SUBJECT: El Segundo Energy Center Project Complaint (12-CAI-05)

EL SEGUNDO ENERGY CENTER PROJECT
DOLEN COMPLAINT (12-CAI-05)
ENERGY COMMISSION STAFF REPORT

JSA Drawings – Revised Concept Study showing elevations of 45th Street Berm

45th STREET BERM
REVISED CONCEPT STUDY

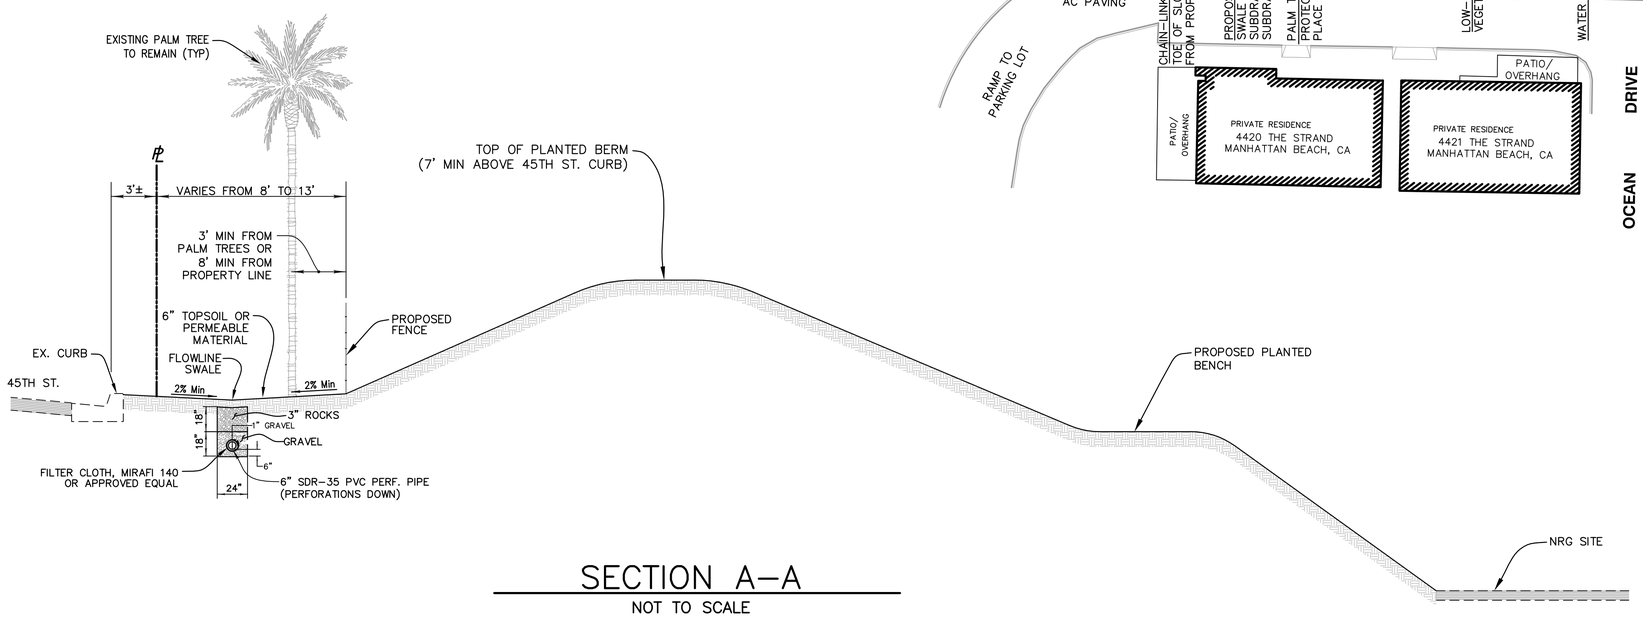
The slope of the earthen berm, as depicted in the complainant's simulation, is not the true top of the slope. In the December 7, 2012 JSA draft drawings provided by ESEC, Sheet 1is a draft revised concept study of the 45th Street berm depicting the re-engineered slope elevations (see **Attachment C**). NRG representatives have also informed staff during past site visits that the height of the earthen berm at the southwestern corner of the project site will be approximately seven feet higher than its current height when completed. Therefore, the simulation provided by the complainant is not a true representation of the most recent plans provided by ESEC.

Preliminary Landscape Plan for entire project site

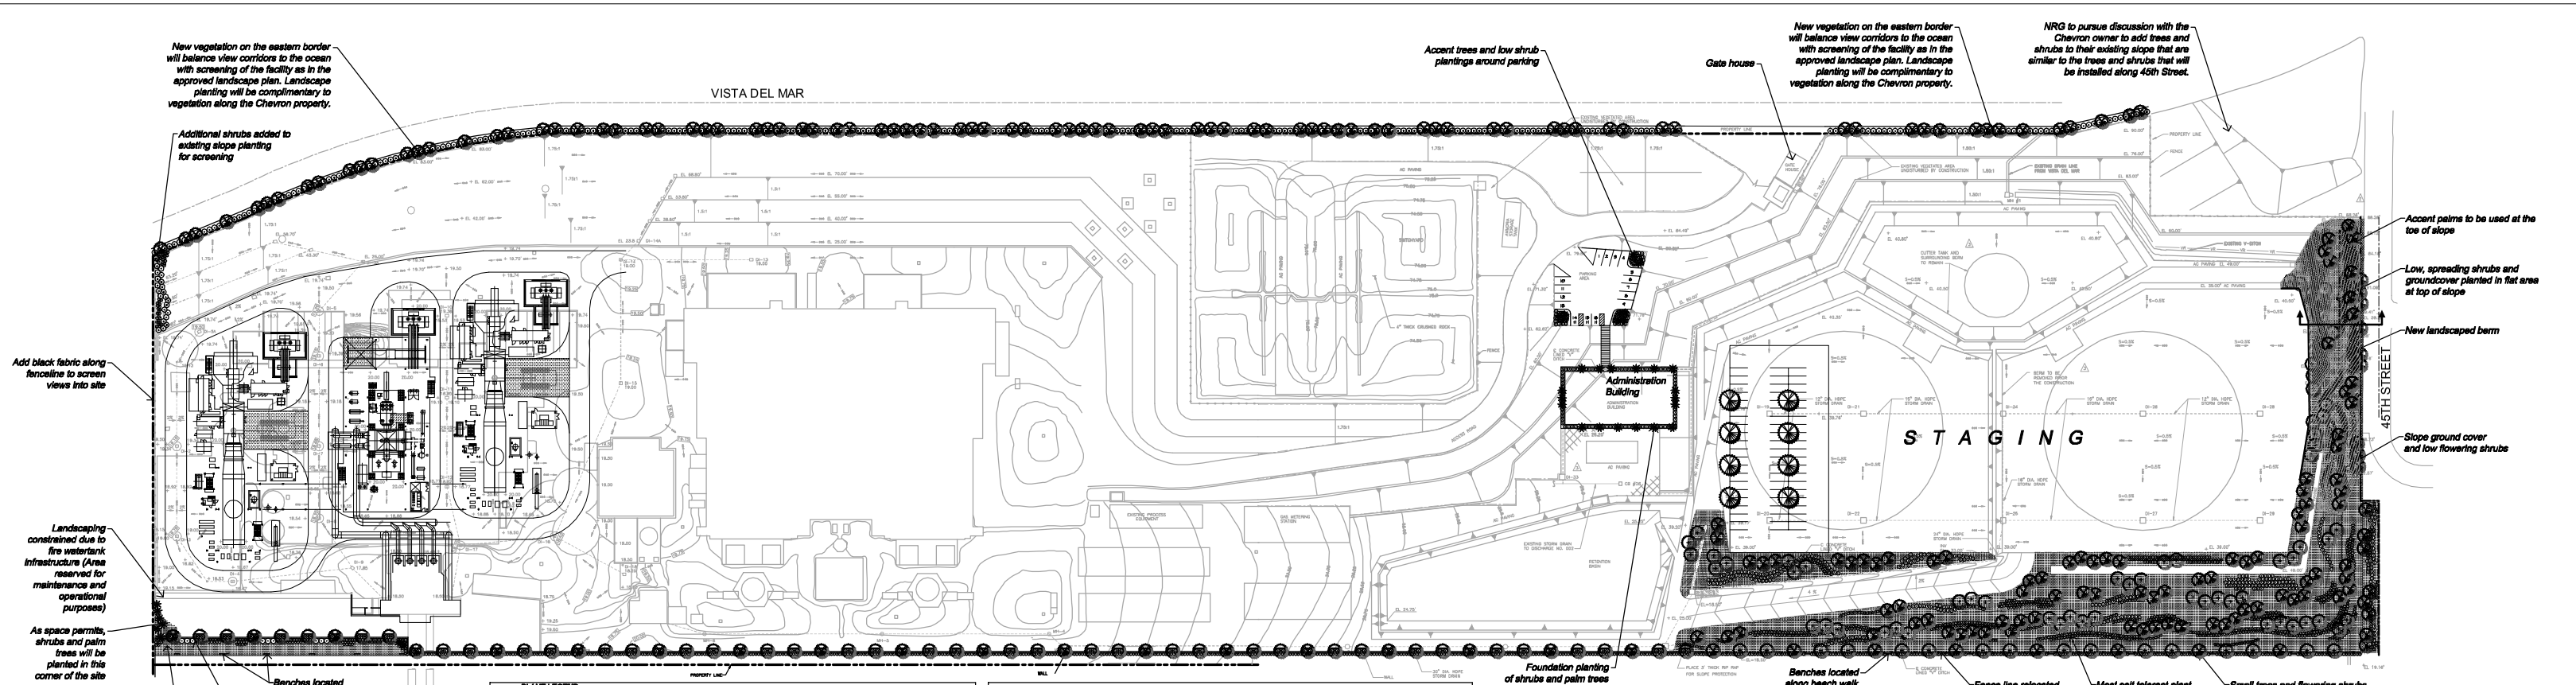
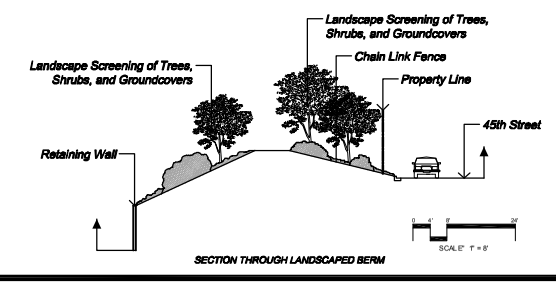
Complaint Figure M refers to a preliminary landscape plan, which indentifies what is marked as the original location for the parking lot on the northern end of the tank farm area and the "currently reported site" location of the overflow parking area at the southwestern corner of the project site. **Attachment D** shows Complaint Figure M in relation to the entire project site.

Staff notes that this drawing is marked as preliminary and the plans revising the slope of the earthen berm are still being finalized. The final plans will be submitted to the Energy Commission staff in the near future for approval. Per these plans, the height of the earthen berm will be higher than what is depicted in these figures and will further screen any vehicles from view. Staff believes the increased height of the re-engineered berm will change the height of the proposed trees and shrubs potentially shielding more of the facility and overflow parking area from view.
